Explanation of Significant Differences

**Explanation of Significant Differences
from the Record of Decision for the
Technical Support Facility Injection Well (TSF-05)
and Surrounding Groundwater
Contamination (TSF-23) and Miscellaneous
No Action Sites, Final Remedial Action**

**Operable Unit 1-07B
Waste Area Group 1**

**Idaho National Engineering and Environmental Laboratory
Idaho Falls, Idaho**

Figure 2.

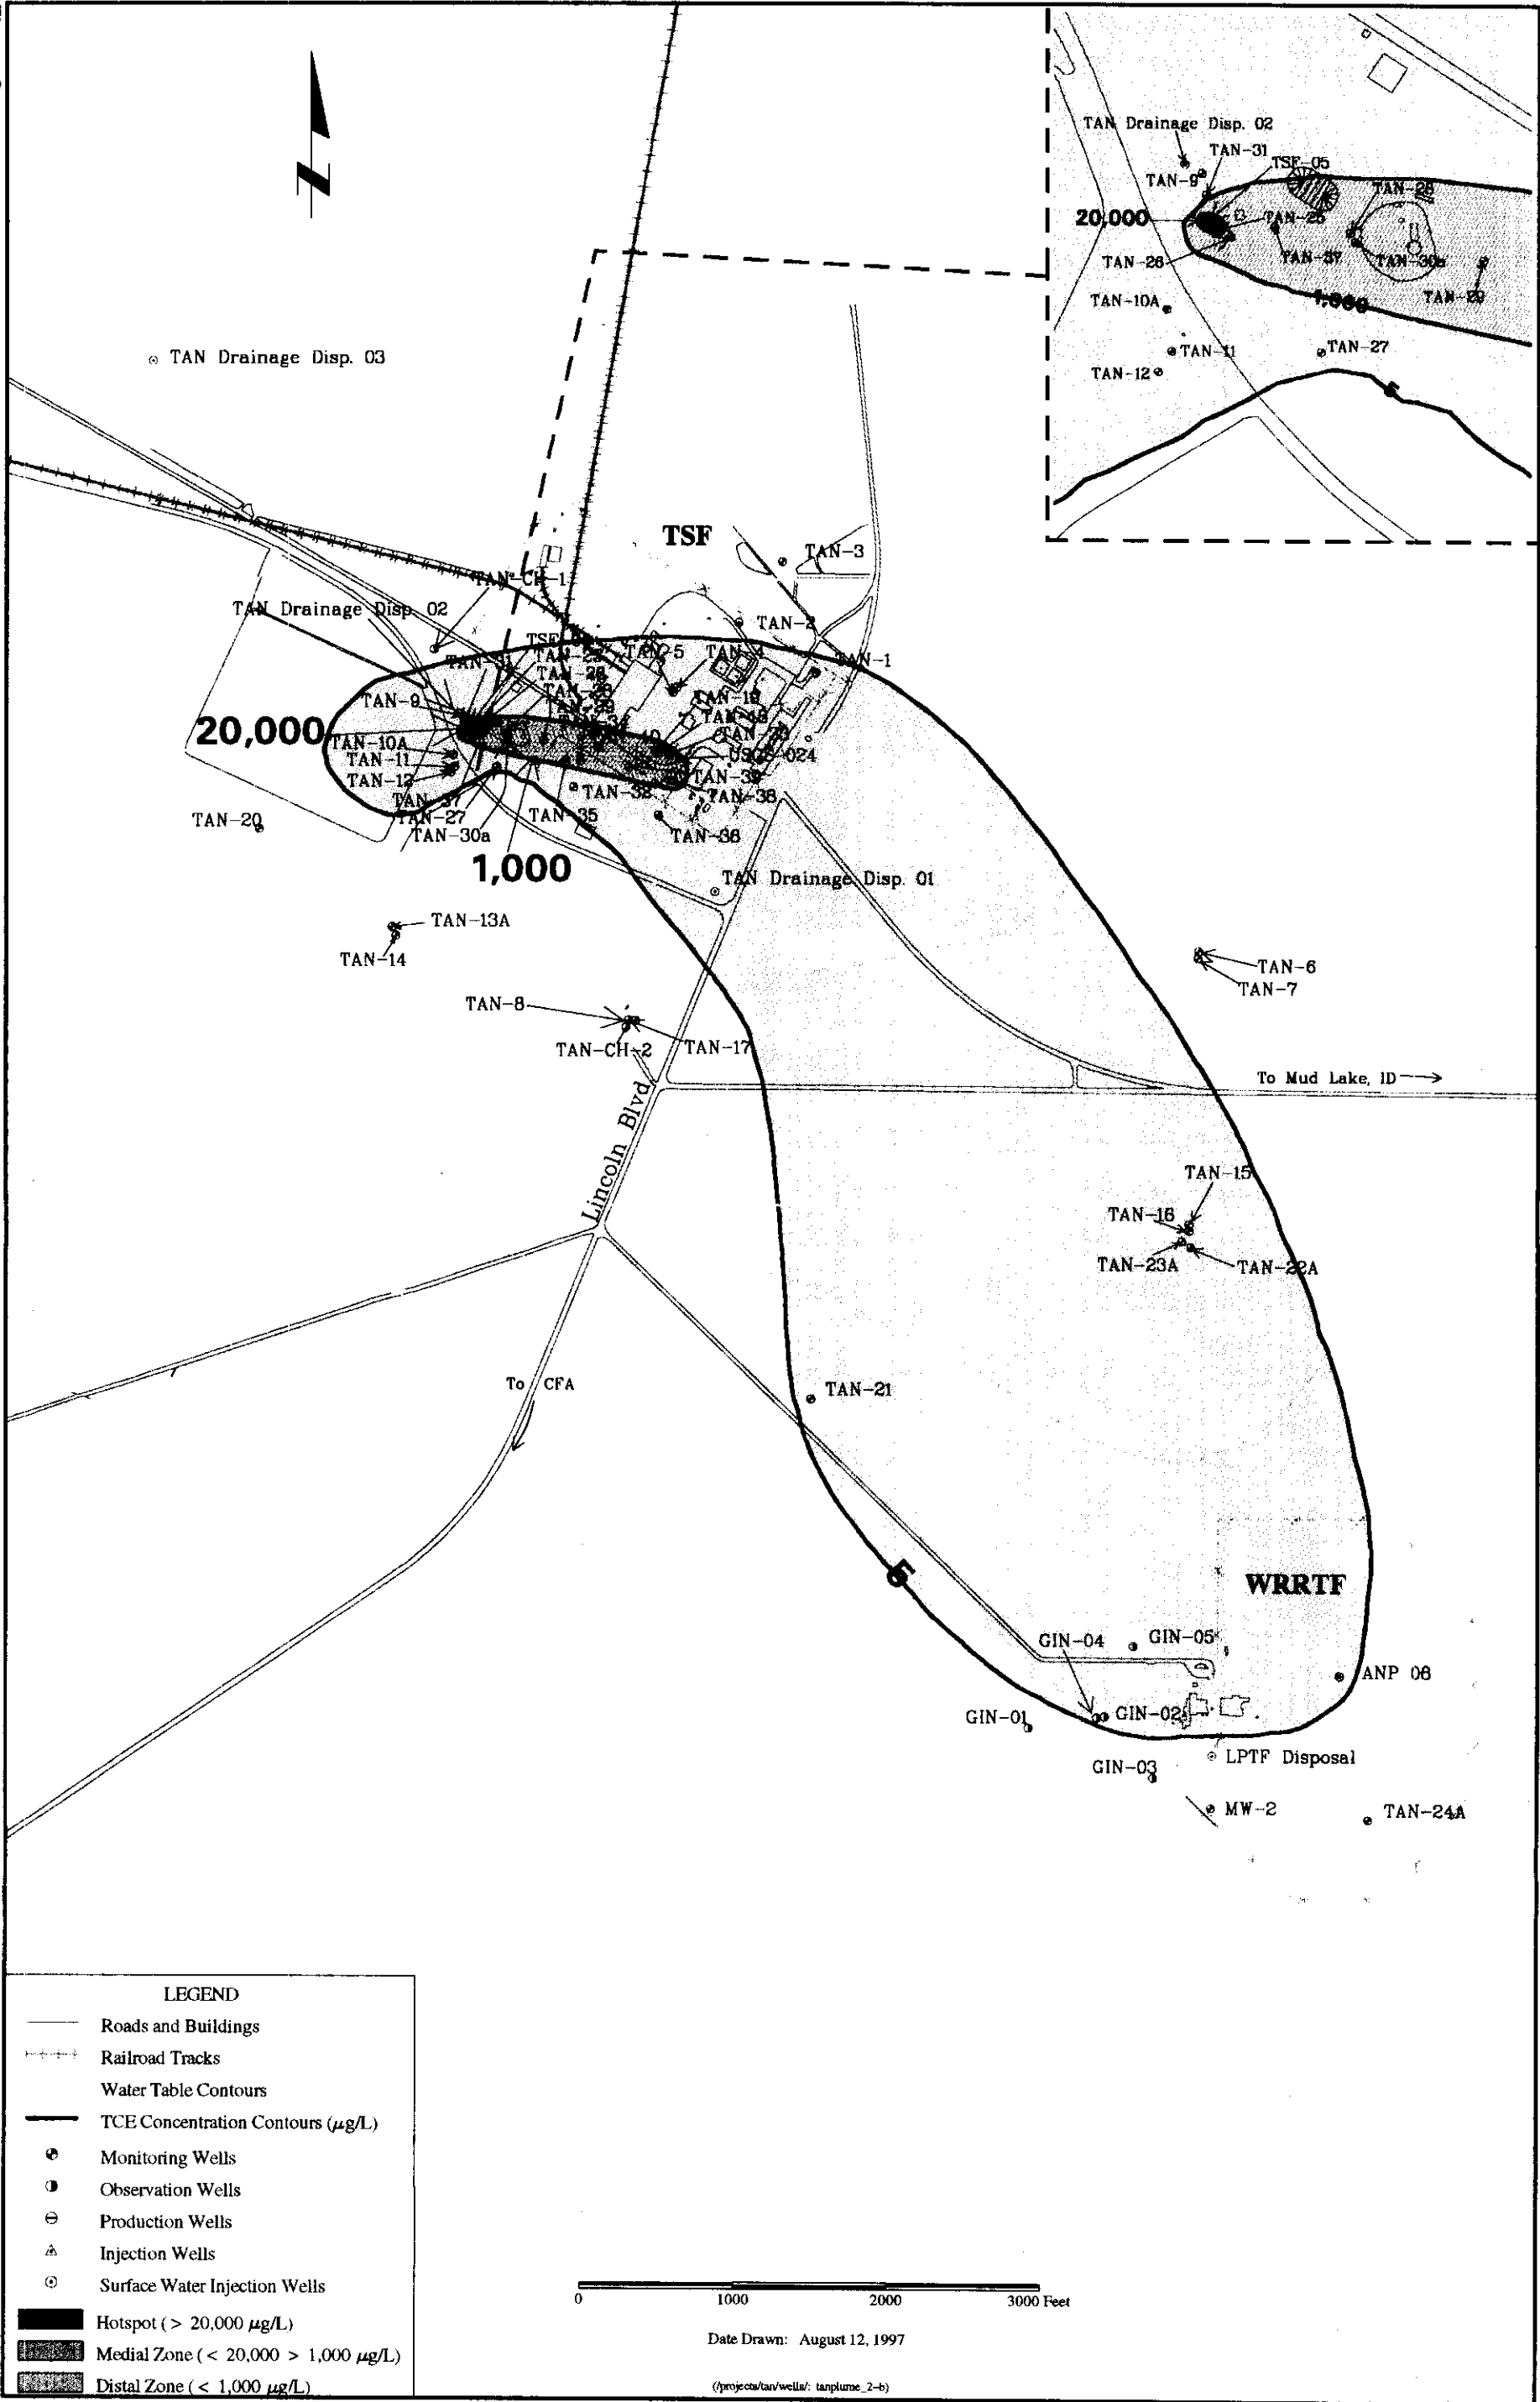
- **Plume Area Definition** - The new information provides the opportunity to improve the focus of the remediation efforts by refining the ROD Hot Spot and dissolved phase plume definitions as shown in Figure 2. The refined area definitions are:

- * Hot Spot (greater than 20,000 µg/L TCE)
 - * Medial Zone (dissolved phase 1,000 to 20,000 µg/L TCE)
 - * Distal Zone (dissolved phase 25 to 1,000 µg/L TCE)
